MEETING AGENDA

7.	Sanitary: Amendment No. 1 to the Agreement for Technical Services for the Poplar Creek Lining Project.	X
8.	Plan Commission: Recommendation for Final Approval for a new warehouse building for Master Spa Warehouse located at 21675 Doral Rd.	X

**TOWN OF BROOKFIELD
PLANNING COMMISSION RECOMMENDATIONS
MAY 28, 2024**

Strand Associates, Inc.® (Strand) has finished its review of the plan package for the Avery and Birch Development that was received from ACS, Inc. on May 7, 2024, for conformance with the Town specifications and general engineering practices. Before construction may begin, the contractor shall submit all required permits for the development to the state, Wisconsin Department of Natural Resources, Town, and any other relevant agencies. New drawings and a letter describing the revisions should be returned to Strand after the following concerns have been addressed.

VEHICLE TURN EXHIBIT (WB-40 SEMI)

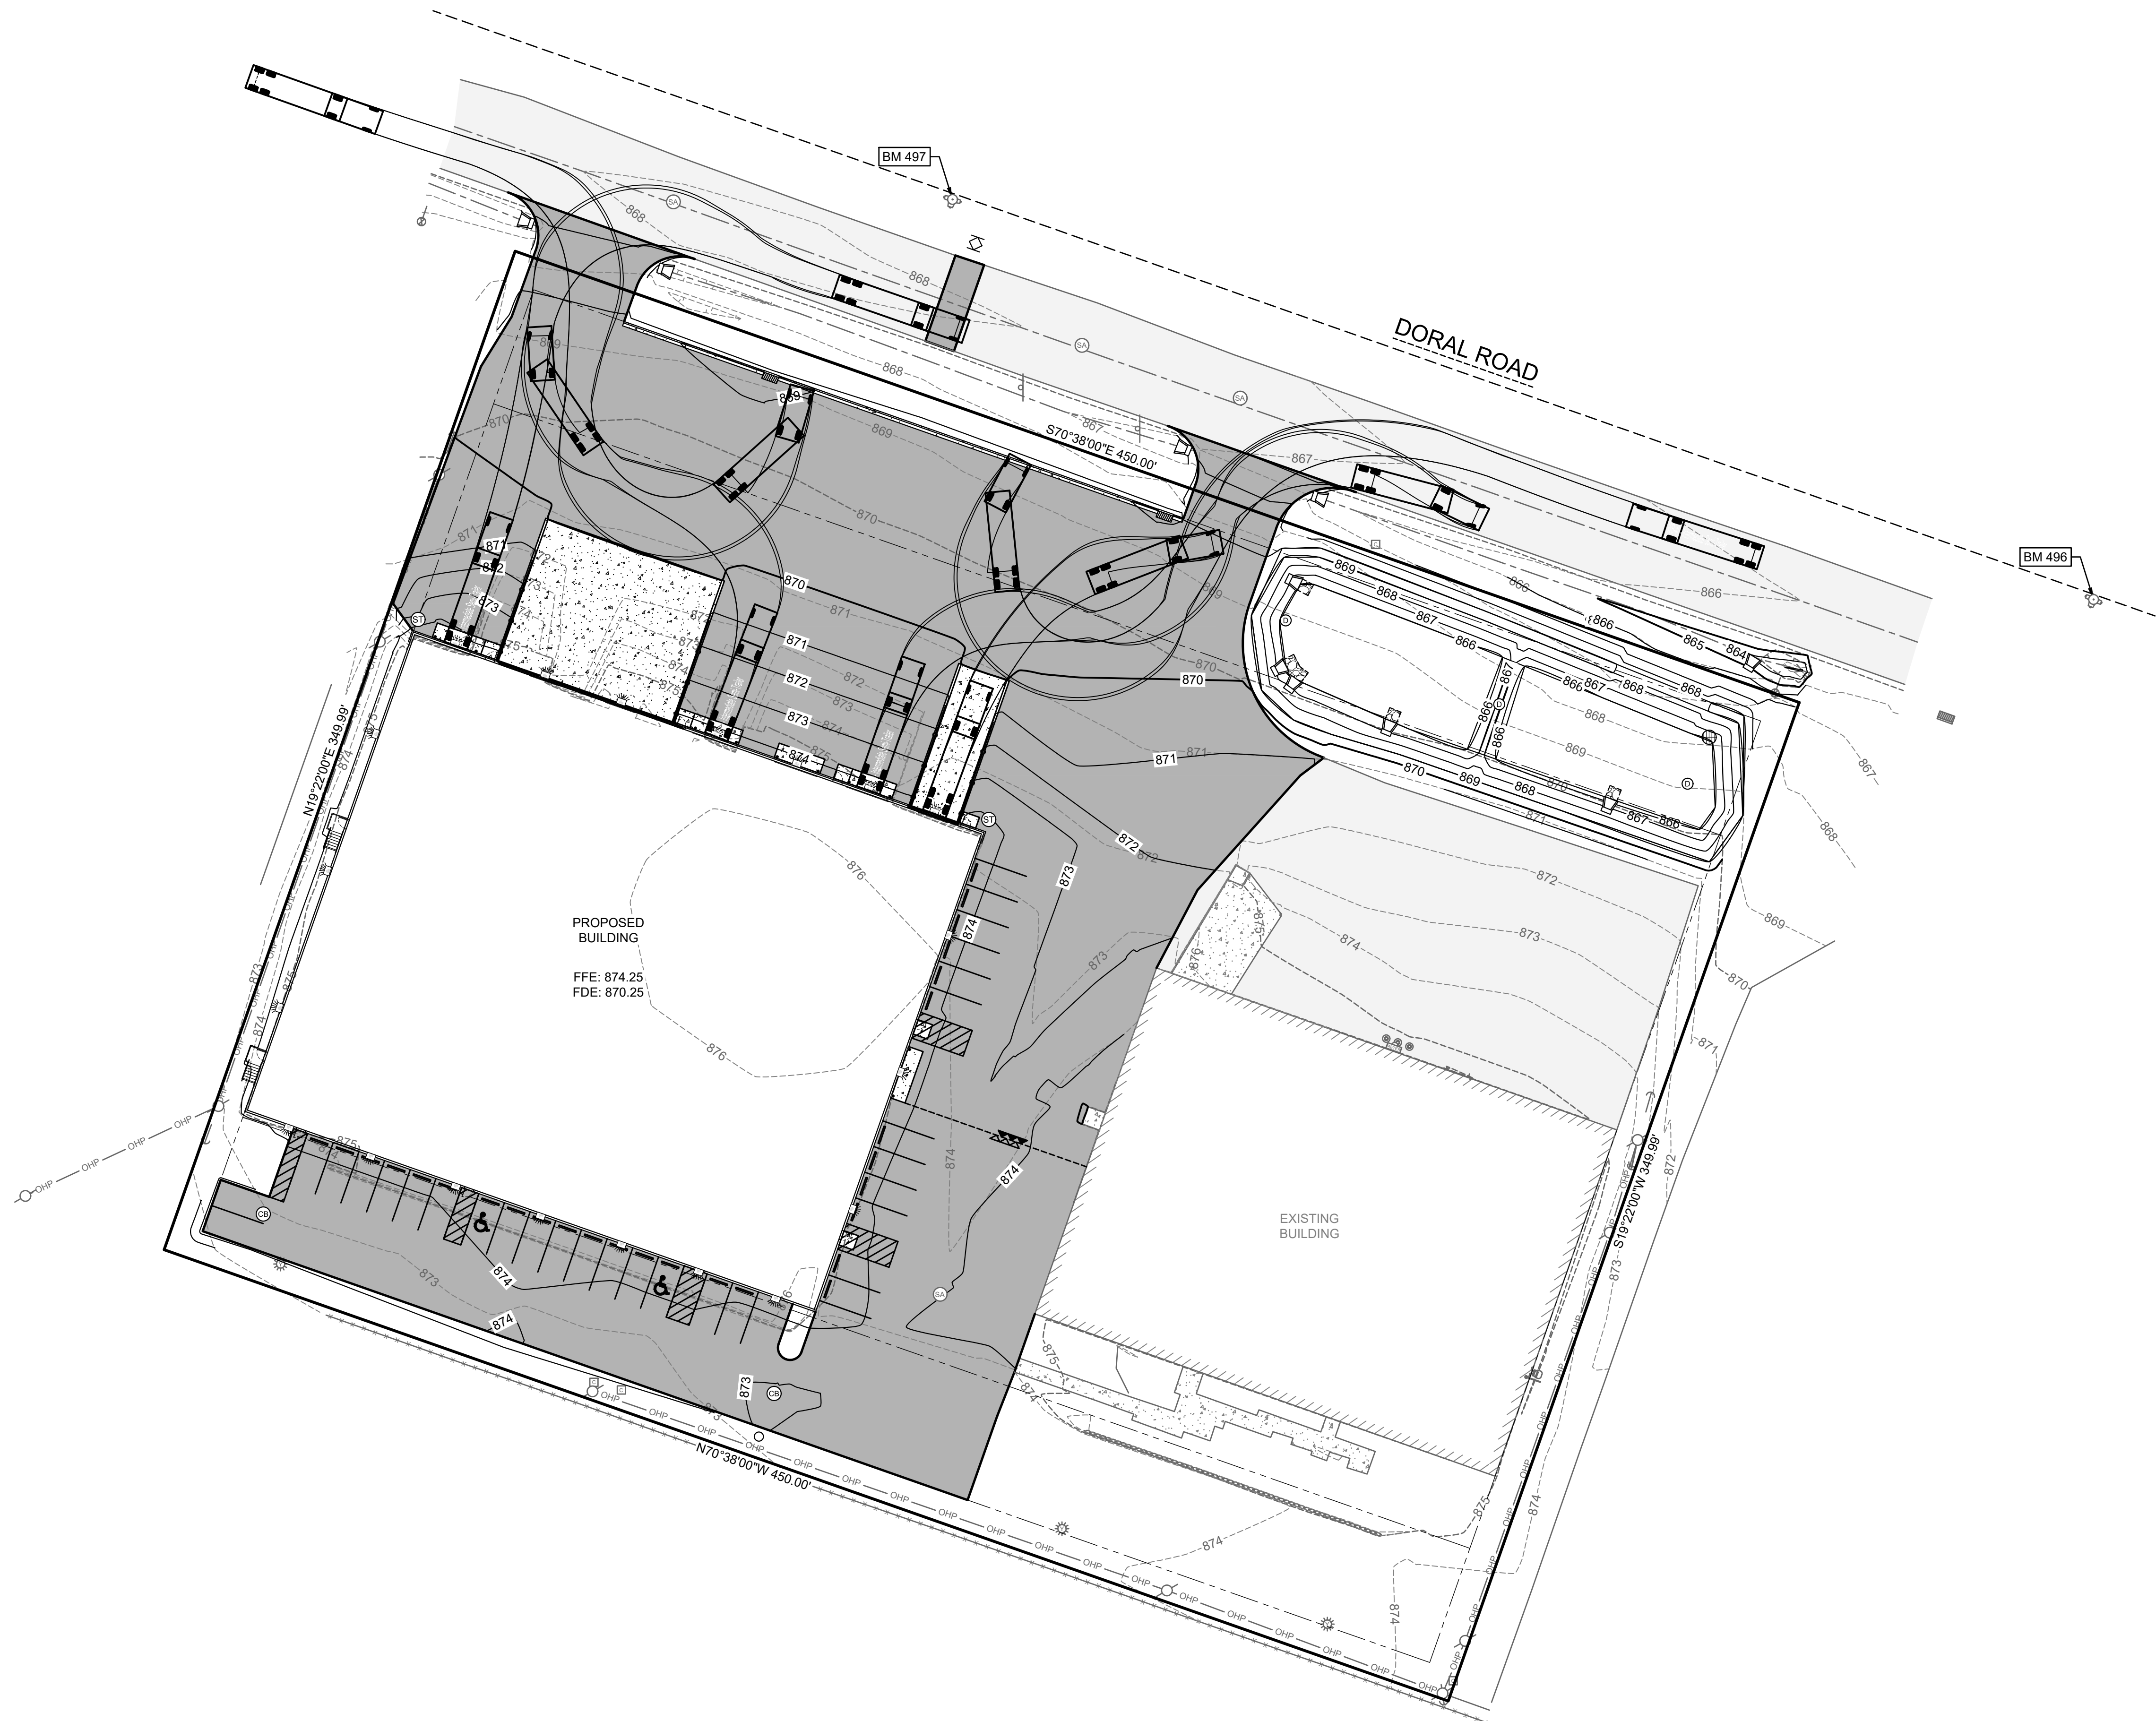
3. A turning-moving exhibit should be provided to verify the largest vehicle (including any emergency vehicles) that will access the site can perform the required turning movements with the proposed layout.

- a. **Mach IV Response–A vehicle turning exhibit for a WB-40 semi-trailer has been included with the final plan commission submittal package.**
 - b. *Strand's Current Comment–Turning template was reviewed and there is no further comment.*
